Land off Chelford Road, Henbury, Macclesfield

Review of Surface Water Drainage and Flood Risk

Technical Note

Project ref:	4719 – Land off Chelford Road, Henbury, Macclesfield
Prepared by:	Rebecca Murphy BSc (Hons) <i>Associate Director</i>
Approved by:	Andrew Grime BEng MBA CEng C.WEM MICE FCIWEM <i>Director</i>
Date:	19 December 2019
Version:	Final v1.2

Figure 3: Flood Risk from Surface Water
 (Source: gov.uk website)

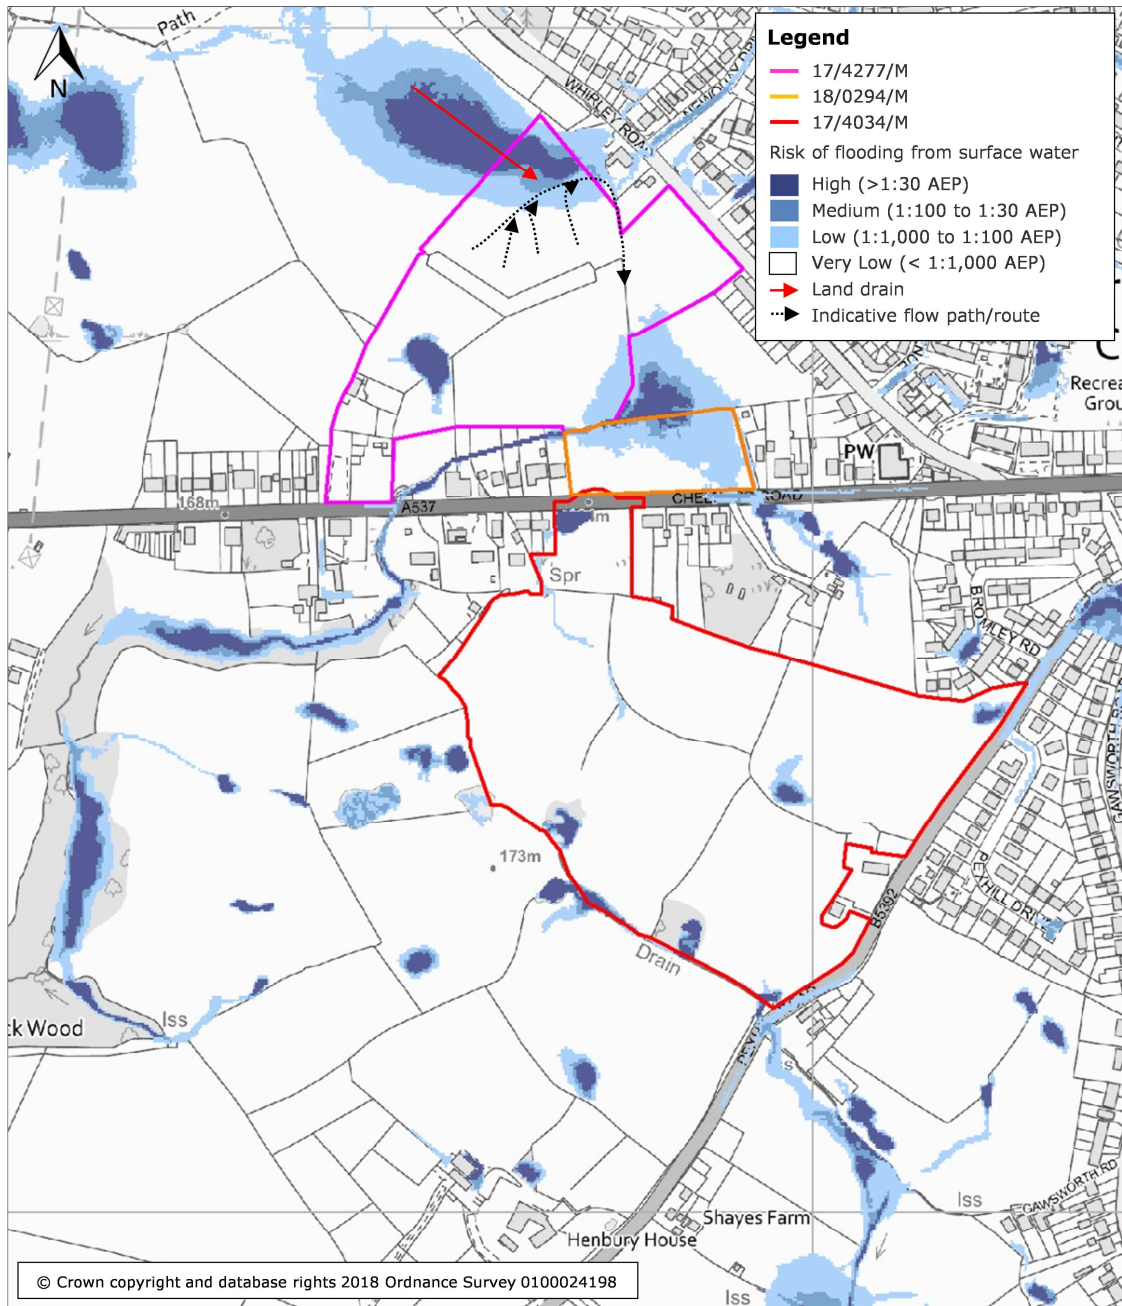
12. The Flood Risk from Surface Water map (**Figure 3**) indicates that there is a risk of flooding to each site, some of which is associated with the existing watercourses within the vicinity.

13. Potential depths and velocities for the low, medium and high risk surface water flooding events are summarised below for each site:
 - 17/4277/M Flood extent is generally confined to an area in the north and south of the site, with the latter associated with the watercourse between the site and 18/0294/M. Flood depths of 300-900 mm expected during the high and medium risk events and in excess of 900 mm during the low risk event. Flood velocities are generally expected to be less than 0.25 m/s with some intermittent areas over 0.25 m/s.

19. The flood risk assessments identified limited flood risk to the sites, with no specific mitigation measures subsequently proposed. The only exception is the proposed restriction of development in the north of 17/4277/M within the area of identified surface water flood risk (**Figure 3**). It is not clear whether this has been taken into account on the proposed layout submitted as part of the reserved matters application for this site (19/3097/M) as development appears to encroach within this flood outline.

- Confirmation that all development is to be located outside the existing areas of surface water flood risk identified in **Figure 3**, particularly in respect of 17/4277/M and 18/0294/M. Where this is not possible, suitable measures should be incorporated in order to ensure that flood risk is not increased elsewhere as a result of the proposed developments.

Figure 4: Groundwater Flooding Hazard Map
 (Source: Findmaps)

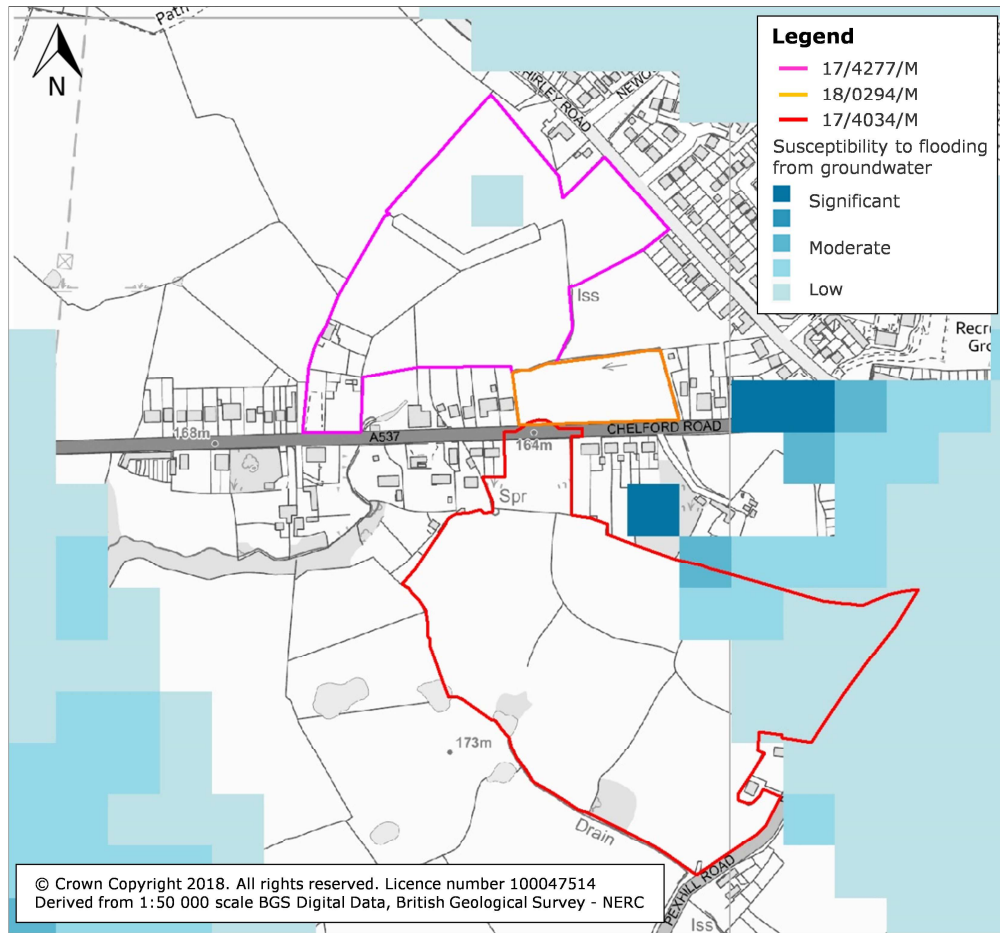
17. According to the British Geological Survey Groundwater Flooding Hazard map (**Figure 4**) the sites are not susceptible to groundwater flooding, with the exception of an area of 17/4034/M in the east which is shown to be at low to moderate risk.

Figure 5: United Utilities Public Sewer Extract

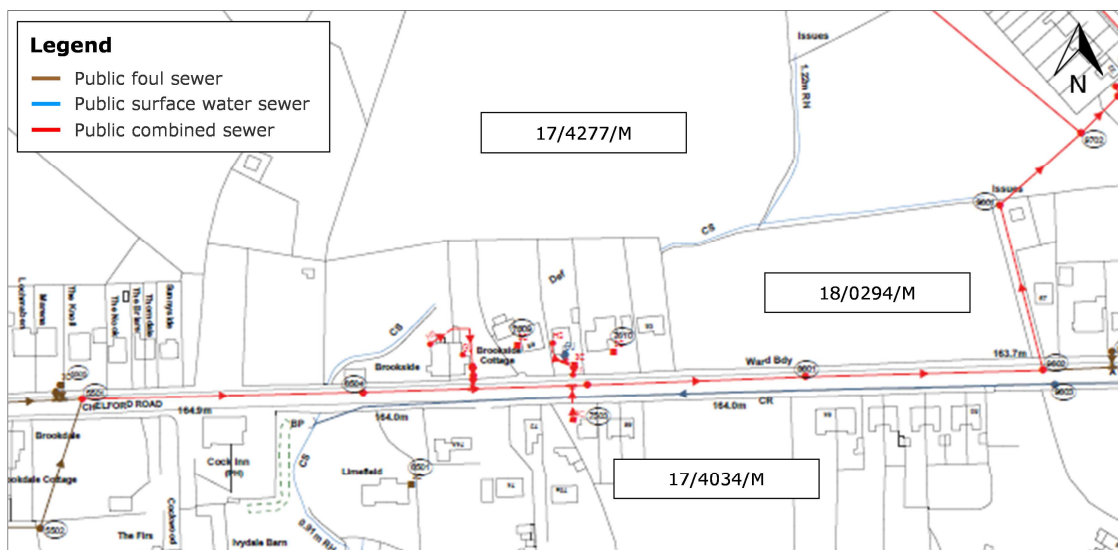
21. The drainage strategy for 17/4034/M also proposes to discharge runoff from a proportion of the site to a public surface water sewer in Chelford Road to the north and Bromley Road to the east; the former ultimately outfalling to the watercourse to the west (refer to the public

- sewer extract in **Figure 5**). United Utilities appears to have provided confirmation that the sewer network is capable of accommodating the proposed discharge rate.

23. The approach outlined in paragraph 20-22 would appear acceptable in principle; however, each site is proposing to discharge surface water to a watercourse (whether directly or indirectly via public sewer) that has an existing propensity for flooding both within the vicinity of the site and downstream (including a contribution to flows through Cock Wood, an ancient woodland, which is designated as a Local Wildlife Site).
